PITS AND BELOW-GRADE TANKS

OIL CONSERVATION COMMISSION HEARING

CASES 14784, 14785   January 9, 2013

Donald A. Neeper, Ph.D.

USDA ELECTRICAL CONDUCTIVITY THRESHOLD (mmho/cm)

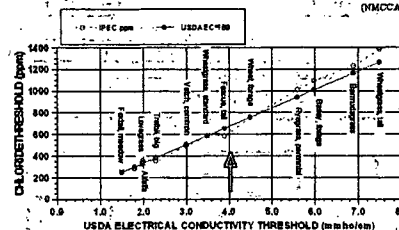
Page 5 presents a method for relating EC to mg/kg. This is not
new information; it is in the record of the hearing, but it may
be obscure. I am not now discussing damage to vegetation. I am
using two data sets to show the conversion between EC and mg/kg,
which is ppm or parts per million. For this purpose, I could
have made a simpler chart, with arbitrary names for the points,
but I preferred to use material already in the record.

EC is electrical conductivity. Consider first only the points
shown on the chart as circles in blue. Imagine each point as
being on the horizontal axis, instead of on a slope. In your
imagination, just move each point down to the horizontal axis
that is labeled EC. For example, move the point called vetch at
EC 3 down until it sits on the horizontal axis. This indicates
the US Department of Agriculture found the effect labeled
"vetch" to occur at EC of 3.

Likewise, imagine moving all of the other circular blue points
down to the horizontal axis. You would then have a horizontal
line with blue circles indicating data points with names,
extending between EC zero and EC 8.0. The horizontal data come
from the U.S. Department of Agriculture.

Next consider the same maneuver, but move the blue circles to
the left, the vertical axis. You would then have a vertical
line with blue circles indicating named data points extending
between chloride values of zero and 1400 ppm, which is mg/kg.
The ppm values come from the Integrated Petroleum Environmental
Consortium of the University of Tulsa. The industry brought the
director of this consortium to testify in the surface waste
hearing.

The names of the blue circles on our imaginary horizontal axis
correspond to the named circles on our imaginary vertical axis,
so you can then let the blue circles move back to the dotted
curve as shown. The blue dotted curve represents two data sets,

one plotted against the other. I indicate an approximate conversion by the red line, which is a fit to the data points below 800 ppm, or below EC of 5. In this fit, ppm (or mg/kg) equals EC value multiplied by 169, the approximate conversion I presented on page 4 of this exhibit.

These are not my data. and the only interpretation of this graph today is that it offers an approximate relationship between expressing chloride concentration as milligrams per kilogram (or ppm) and expressing concentration as EC.. Is this clear?
